## NEEDHAM PLANNING BOARD Tuesday December 21, 2021 7:15 p.m.

# MAJOR PROJECT SITE PLAN REVIEW SPECIAL PERMIT AMENDMENT TO DECISION Application No. 2009-06

#### Town of Needham December 21, 2021

SHEET 1 OF 9

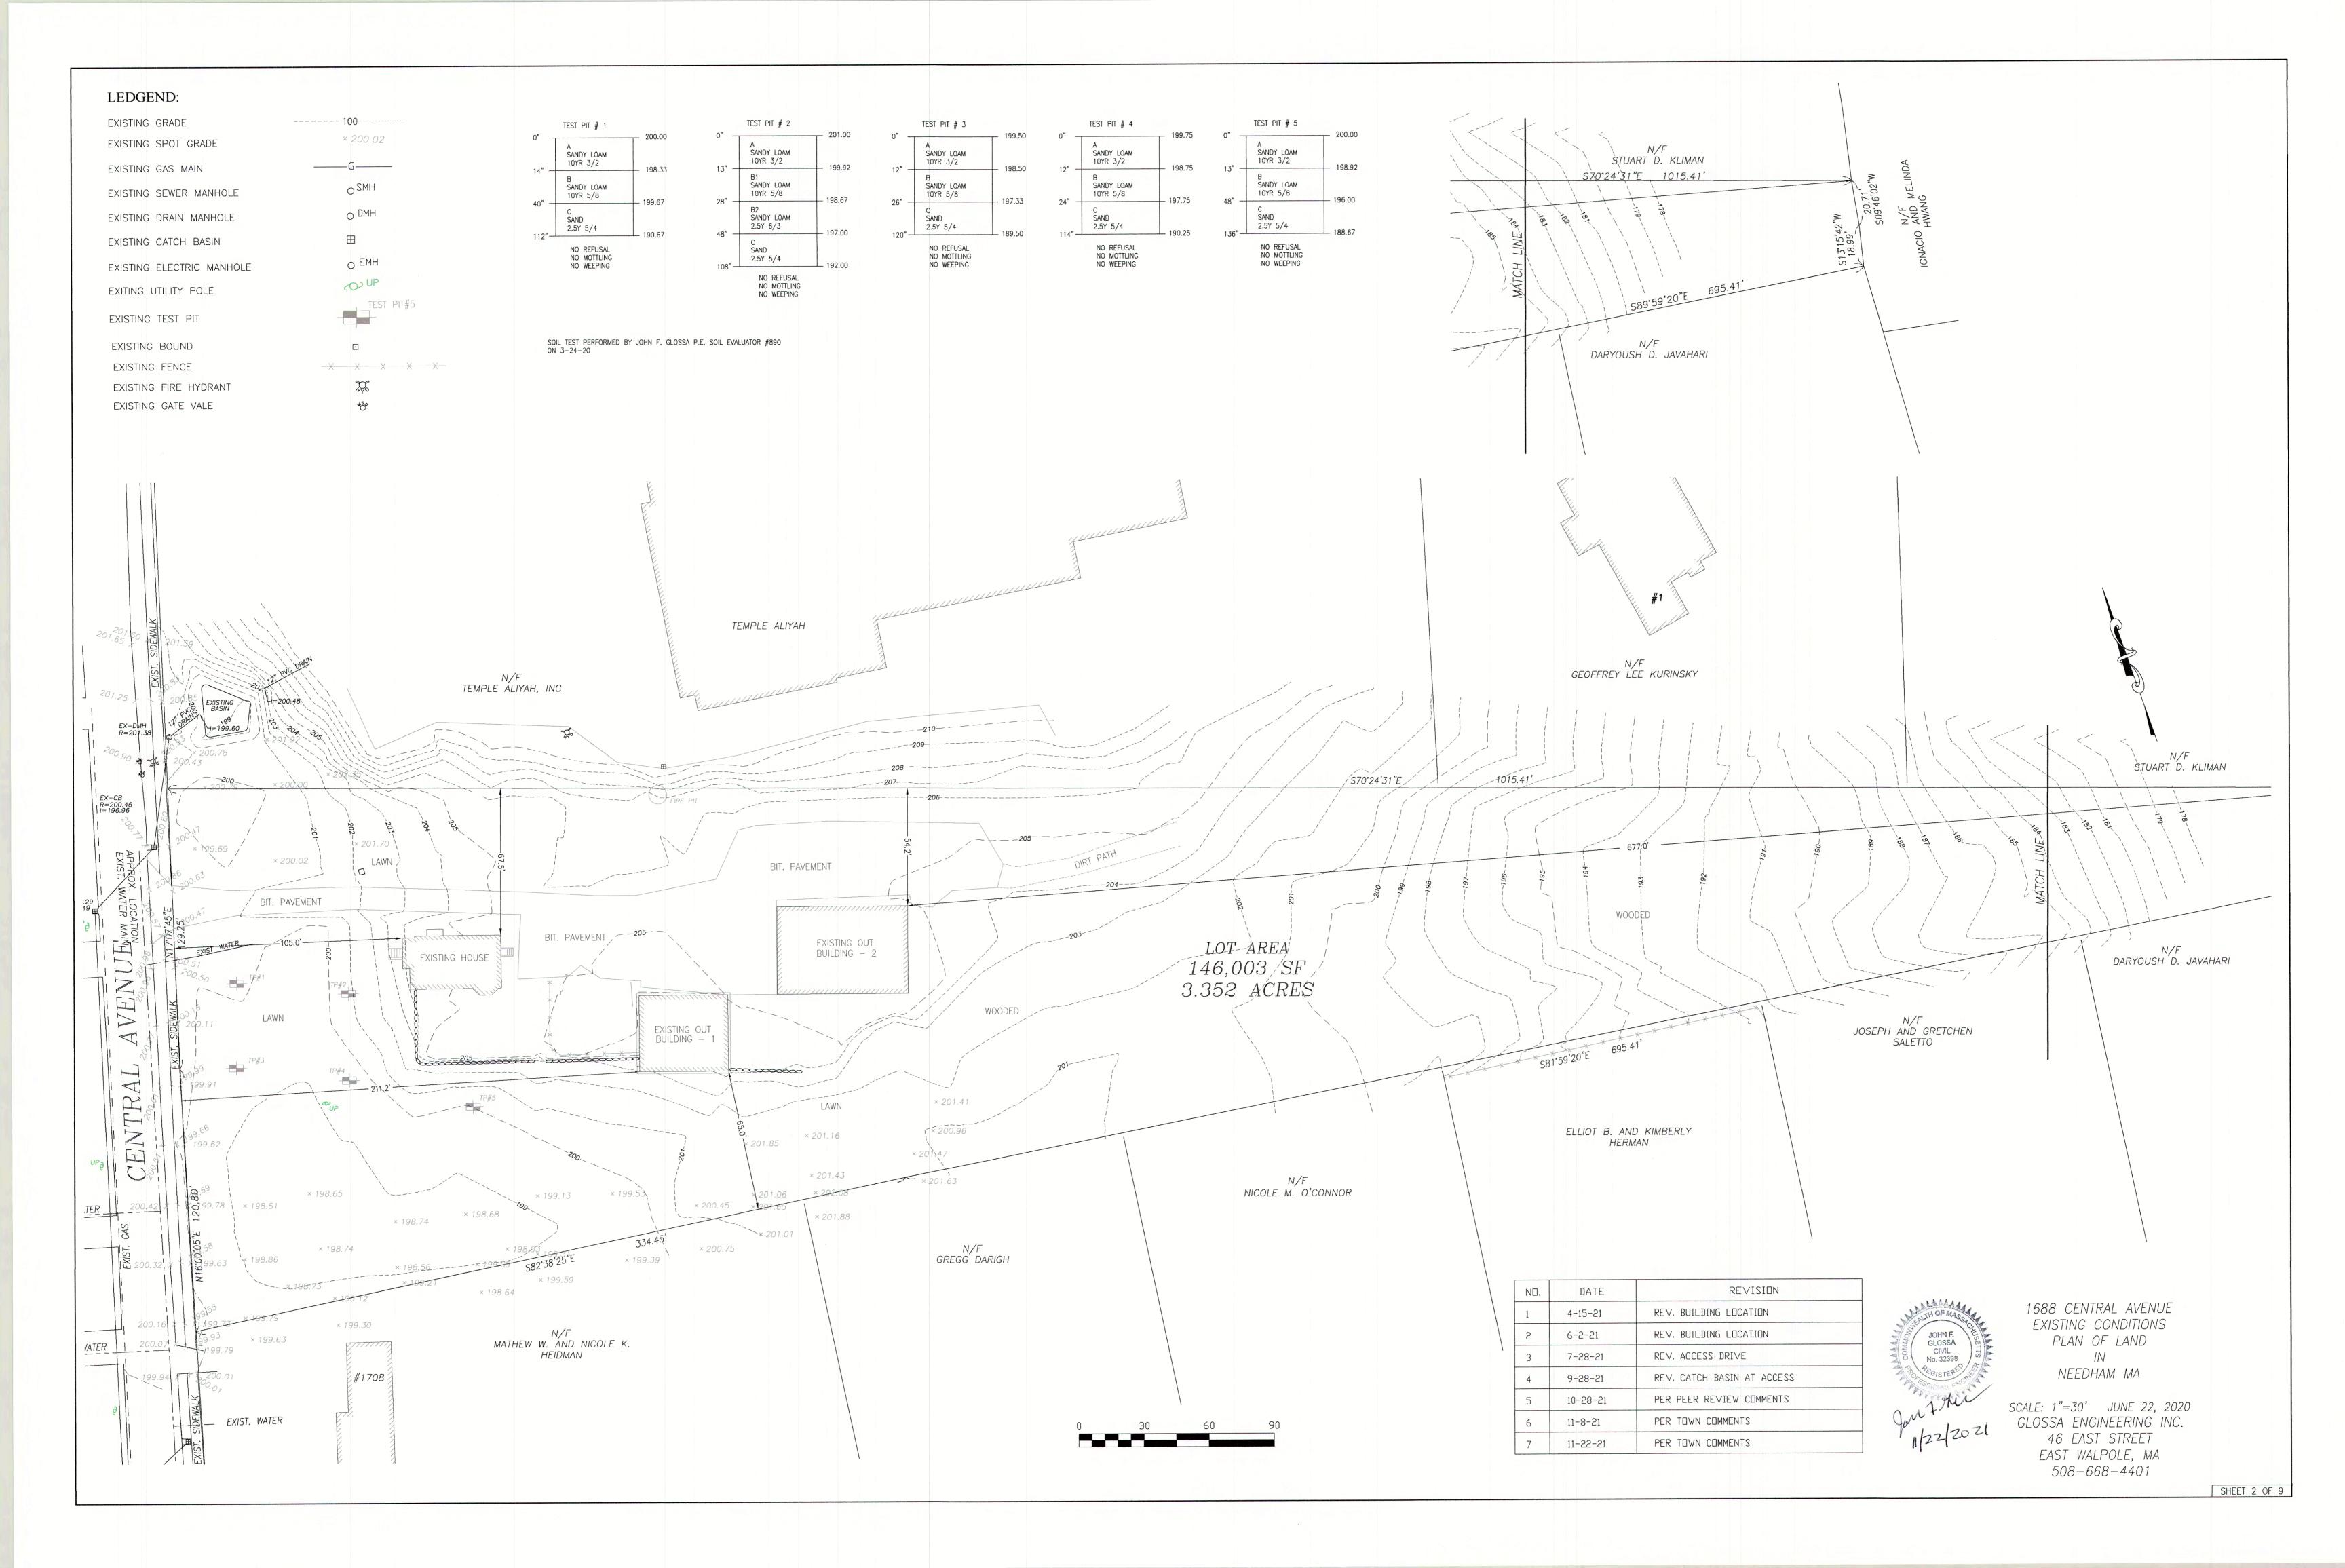
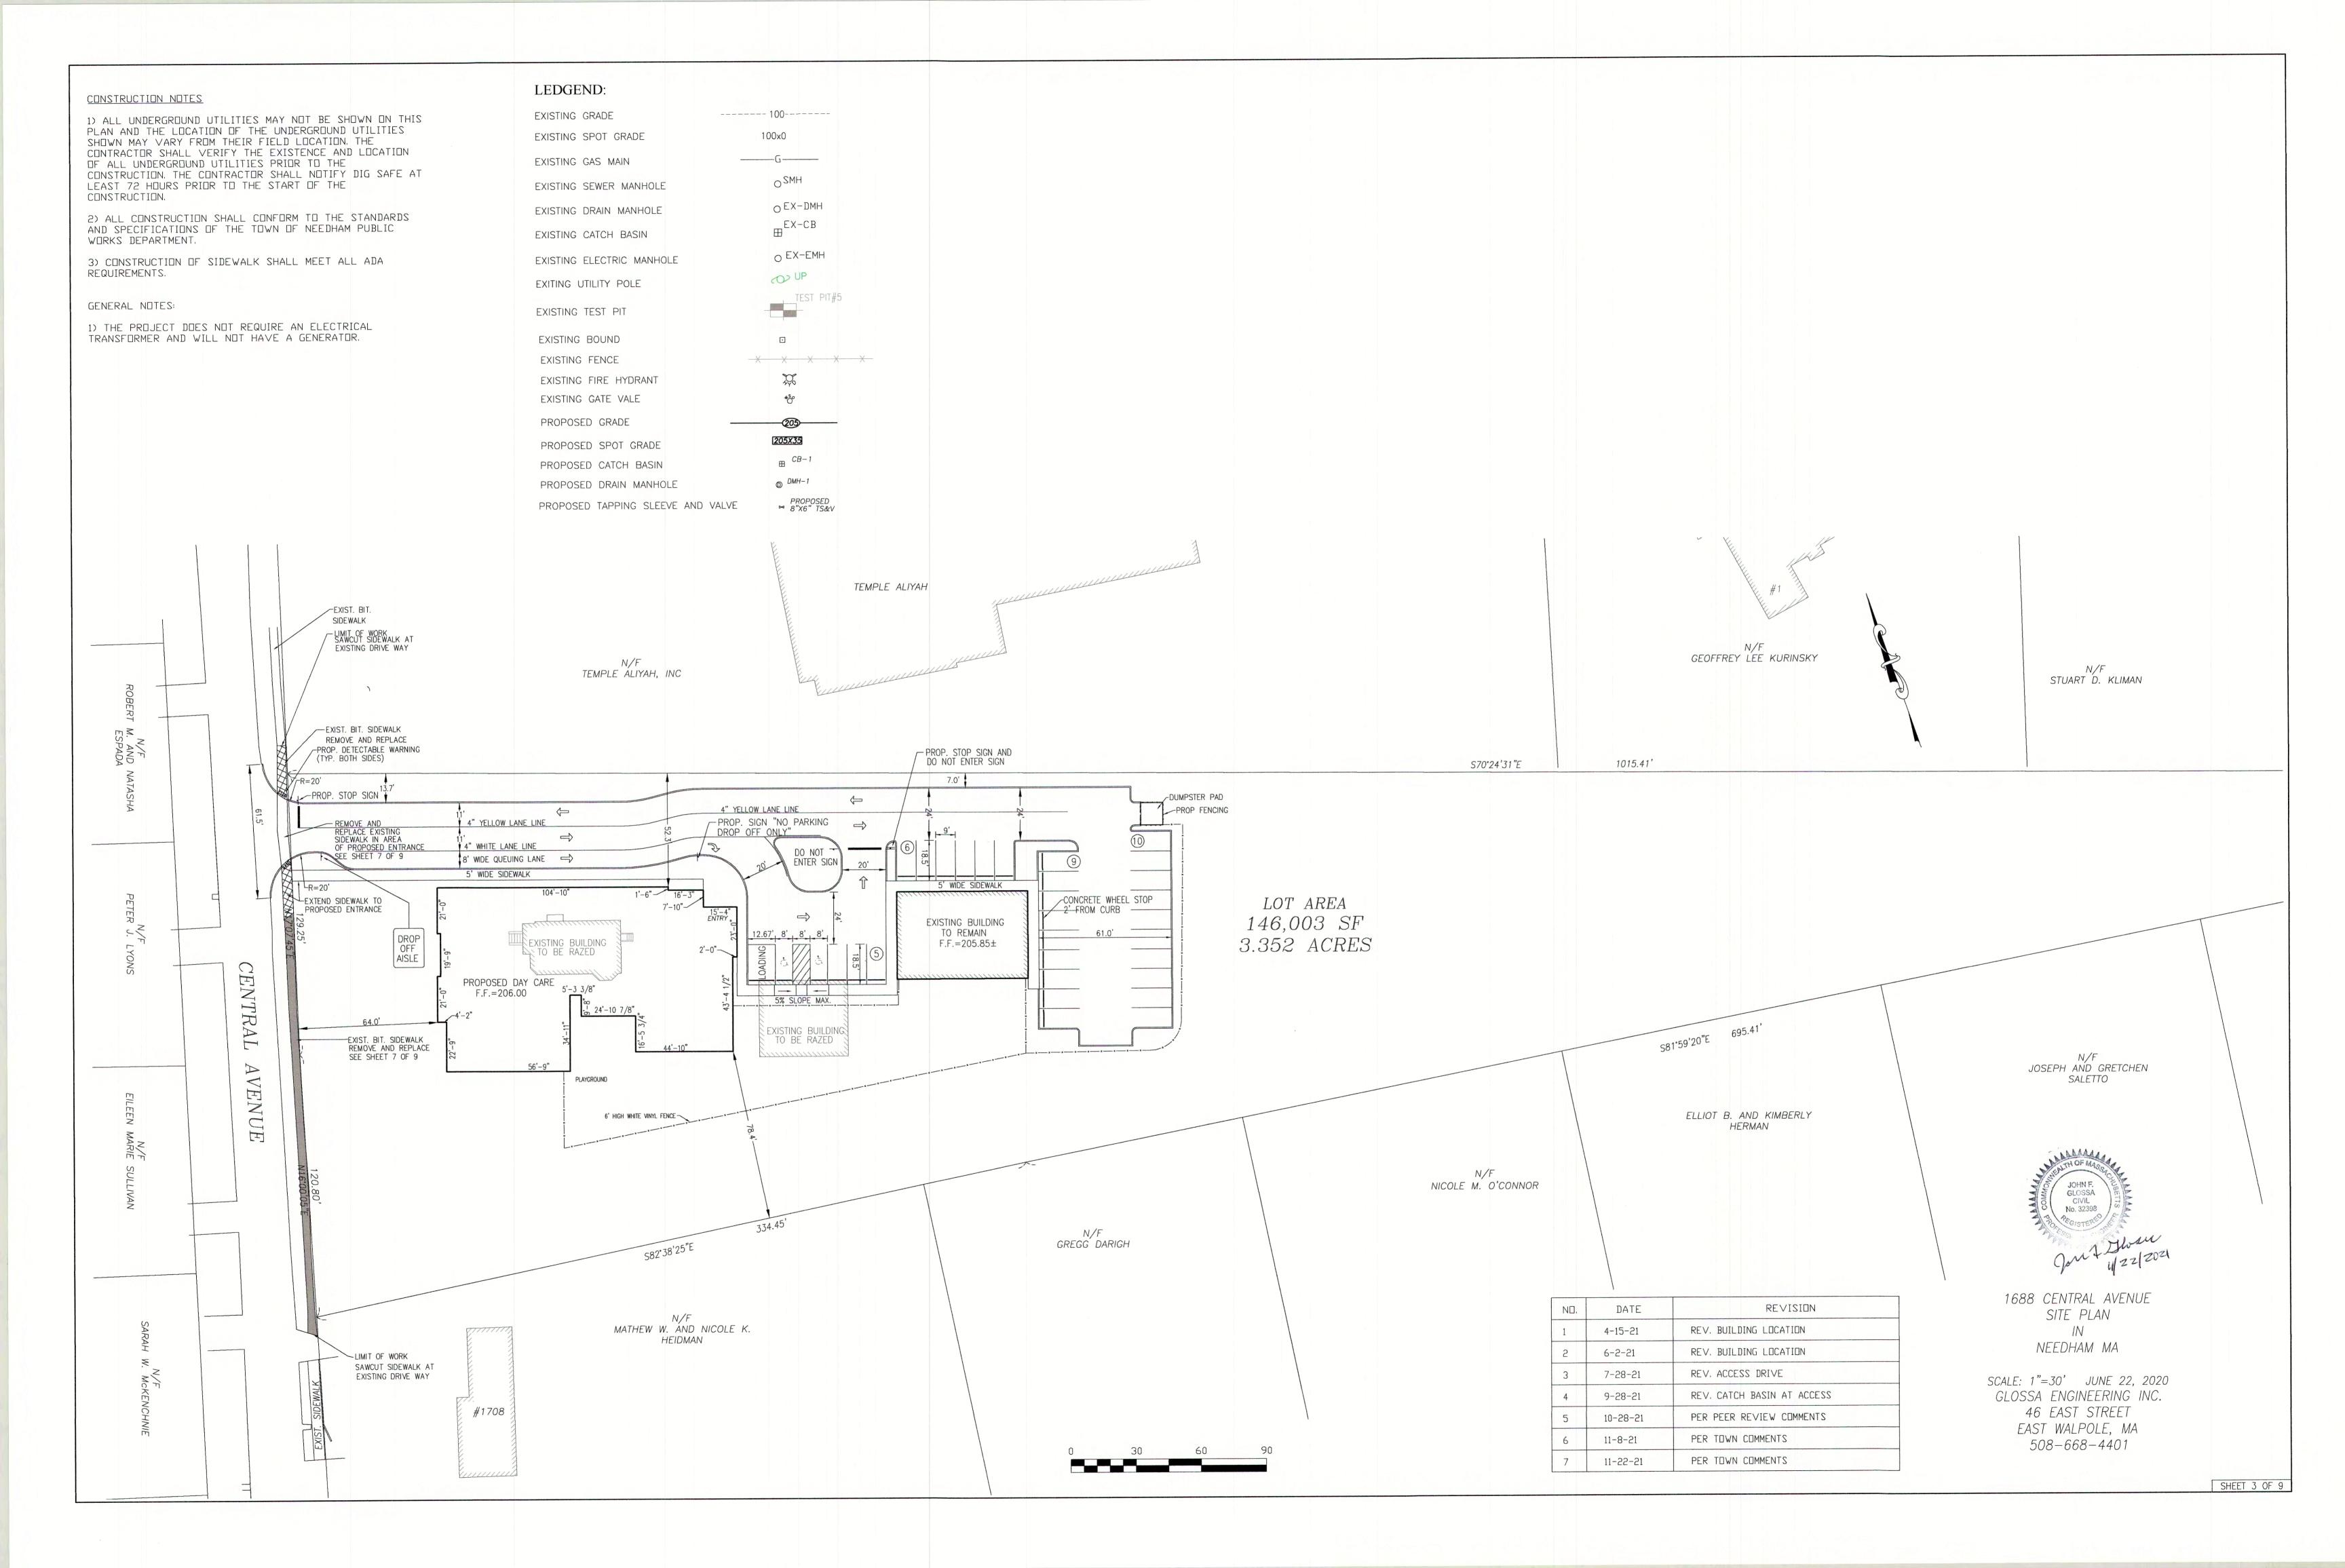
- a) Sheet 4 Proposed grades of the centerline of the driveway apron do not make sense. It appears to slope DOWN from the edge of road to the front of crosswalk by more than 2% and then slope up to the back of the crosswalk by more than 4%

- b) <u>Sheet 4 The spot grades 200x68 and 200x74 indicate the apron slope of about 1% UP at the sidewalk openings and a 1.8%-2.0% slope across the sidewalk/crosswalk, the apron portion should be sloped greater than the crosswalk portion.</u>

- c) Provide grades on sidewalk approaching driveway. It is unclear if the sidewalk slopes to the driveway or is level with the crossing.
- d) Sheet 4 Limit of work on the sidewalks should be indicated (also relates to Comment 2)

- e) Sheet 6 Detail should be provided for the proposed driveway apron.
- f) Sheet 8 & 9 Proposed CBs should be labeled and Existing CB to be removed should be labeled

- g) Sheet 10 Either delete labels on CBs (not relevant for lighting) or correctly label the Existing CB to be Removed
